**INVER GROVE HEIGHTS
PLANNING COMMISSION AGENDA**

SUBJECT: Case No. 12-24 VAC – William Krech
Request for Drainage and Utility Easement Modification on Lot 17, Block 1, Forest Ridge

REQUEST: Comp Plan Amendment, Rezoning, Preliminary Plat, Preliminary PUD Development Plan Amendment and Final Plat and Final PUD Development Approval for Argenta Hills 5th Addition

Re: Revised Argenta Hills 5th Preliminary and Final Plat

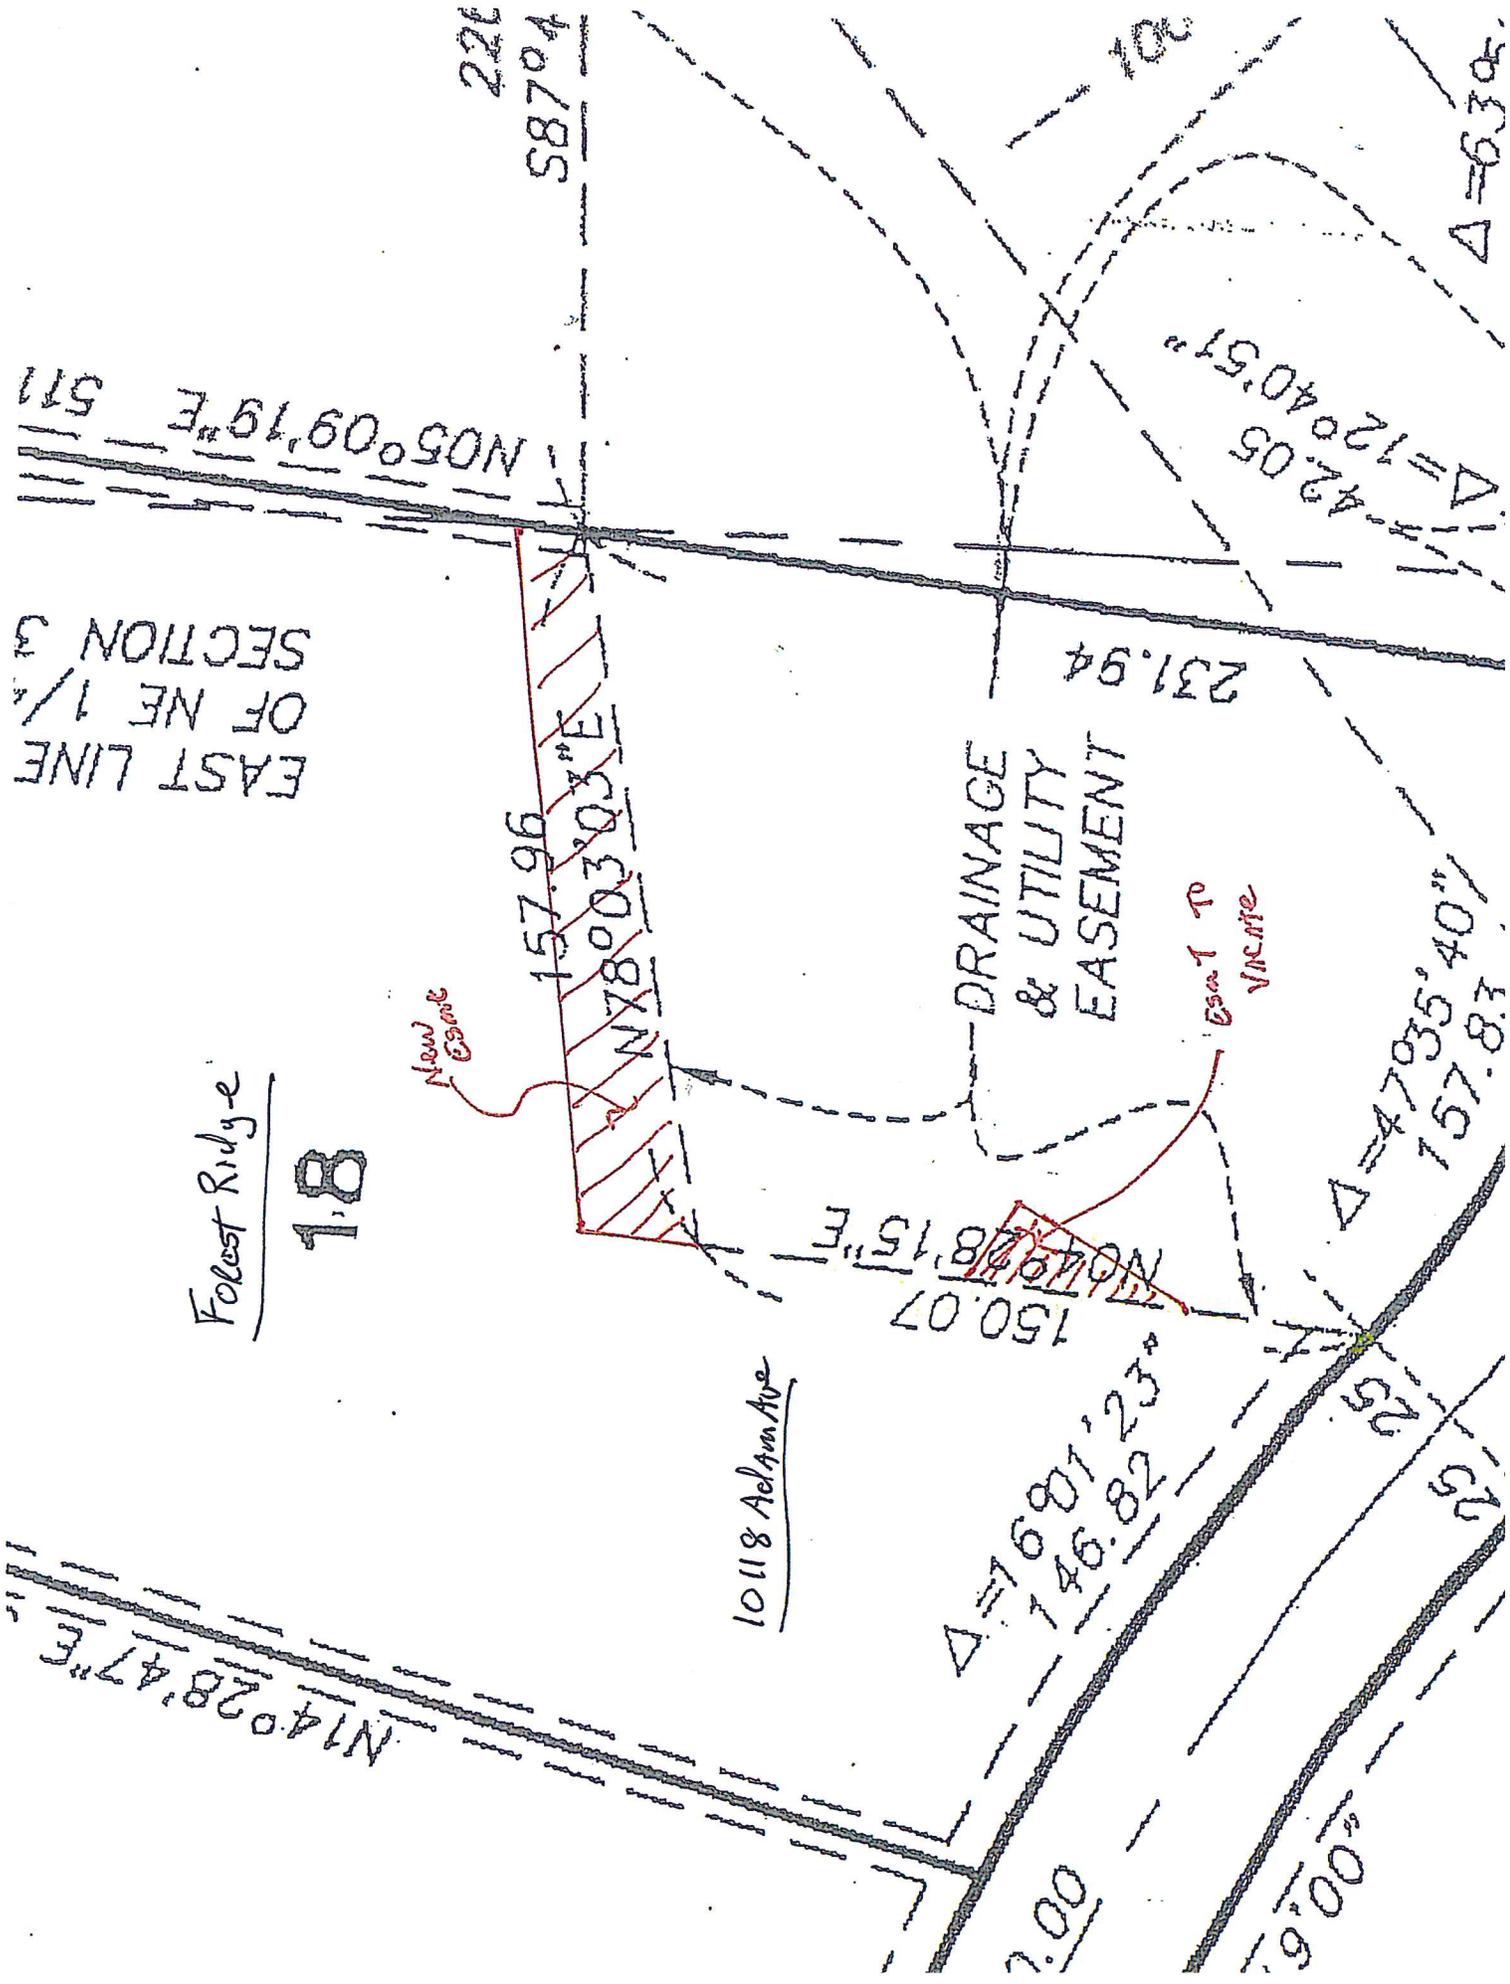
The following concerns were discussed with the owner and his engineer at a July 24, 2012 meeting:

1. The proposed addition would extend into an existing public drainage and utility easement. This is not allowed. The City's preference is to preserve the easement. Note the easement was not affected by the first addition to the house. The developer will enter into agreement to vacate a small portion of the easement and grant additional easements needed for the basin. The developer will provide the legal descriptions. The City Attorney will draft the easement documents. The owner will be responsible for the attorney fees included in the engineering escrow.

2. The existing driveway to the basement level was constructed to avoid impacts on the existing drainage easements and large basin. Attached is a copy of the hydrologic modeling done by Terra Engineering and Barr Engineering showing a regulatory flood level of 834.0. The existing driveway does not impact the modeled storm water plan as reviewed by Barr and approved by the City as part of the original development. Concern was expressed because the First Addition's basement elevation (shown at 834.8) is not 1 foot above the regulatory flood level. The new Second Addition should meet the City Code requirement.

5. The owner and the City Attorney discussed a number of documents which will be needed for this Second Addition to occur as follows:
 - (a) A Custom Grading Agreement should be executed showing the proposed grading plan, an erosion control plan (SWPPP) and a Storm Water Management Plan. The project will require a minimum \$10,000 surety, which may be adjusted upward once the amount of grading is identified plus an engineering and inspection escrow of \$3,000. The escrow will be used for City Engineering review, Barr Engineering review and attorney time drafting agreements. A cost estimate should be provided by the developer's engineer to help establish the surety amount. The owner should provide the escrow and surety as part of the review.

- (c) A document shall be prepared by the City to vacate a portion of the existing easement, shown in red on the Engineer's July 23, 2012 review plan. It is ten feet from the proposed addition. The owner shall provide the legal description.

- (d) A document shall be prepared by the City Attorney to have the owner grant new drainage and utility easements for the expansion of the basin to the north. The owner shall provide the legal descriptions.

- (f) The owner should submit updated plans as discussed at the July 24, 2012 meeting.
6. There is a natural EOF route to the high point at elevation 841. This route must be preserved by the landowner.
